**Subject: Work Plan for Soil Vapor Sampling and Health Risk Assessment,
670 98th Avenue, Oakland, California**

Subject: Work Plan for Soil Vapor Sampling and RBCA Tier II Health Risk Evaluation, 670 98th Avenue, Oakland, California

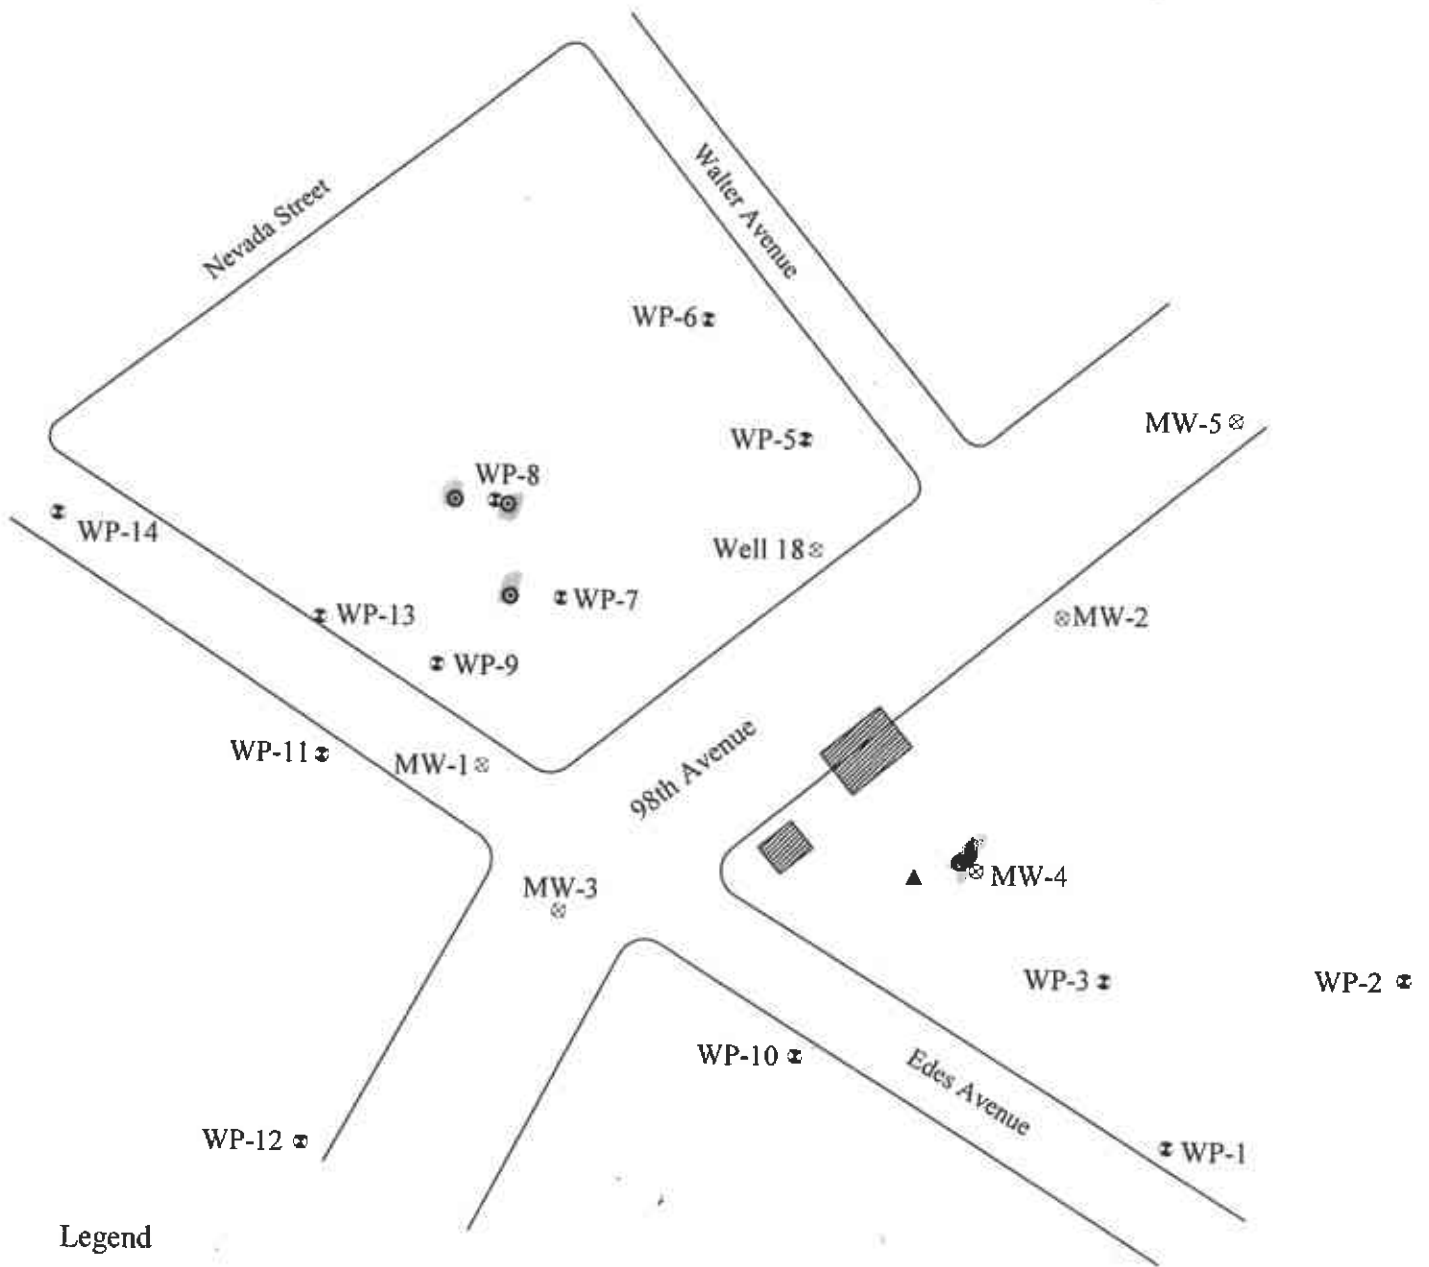
Soil may need to be collected from one boring - preferably from a 'clean' boring assuming lithology at both sides of 98th Ave are similar.
